Amendments to the Drawings

Application Serial Nbr 09/692,990
Replacement Sheet

FIG. 4B

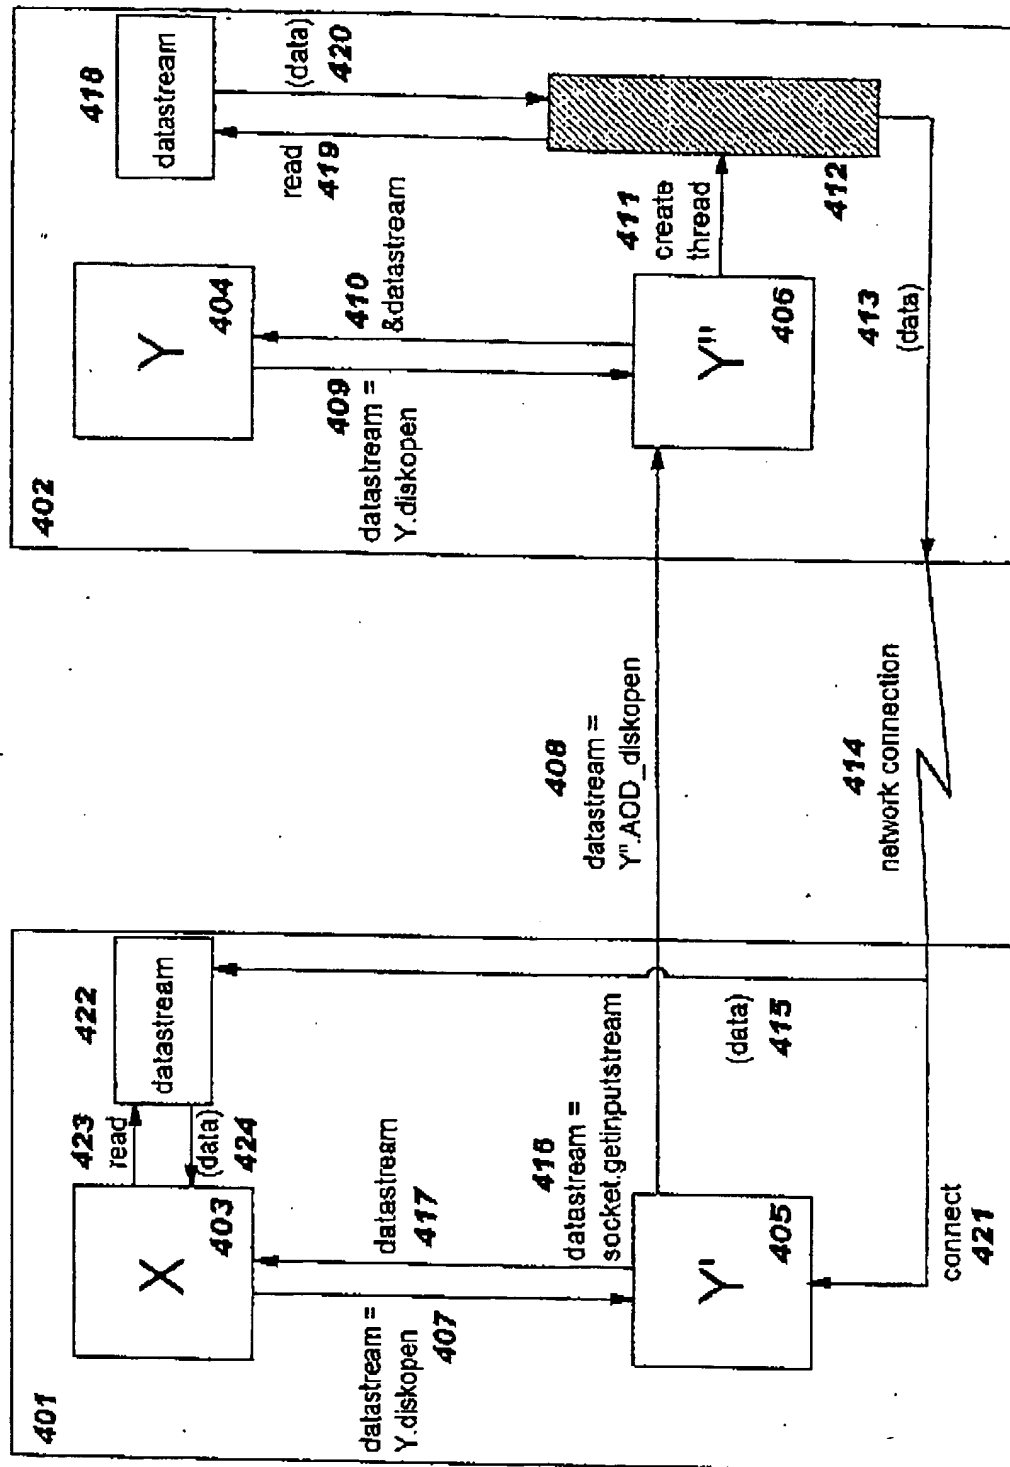
A proposed correction to **Figure 4B** adds an ampersand symbol for element 410, such that it now reads "&datastream". This is supported in the specification on page 14, line 21 - page 15, line 1, which states that the result 410 is passed "in the form of a reference to a datastream object"; the ampersand symbol is well known to indicate an object reference. (See also page 9, lines 20 - 21, discussing a similar data stream object reference 417, which is shown in **Figure 4A** as including an ampersand.)
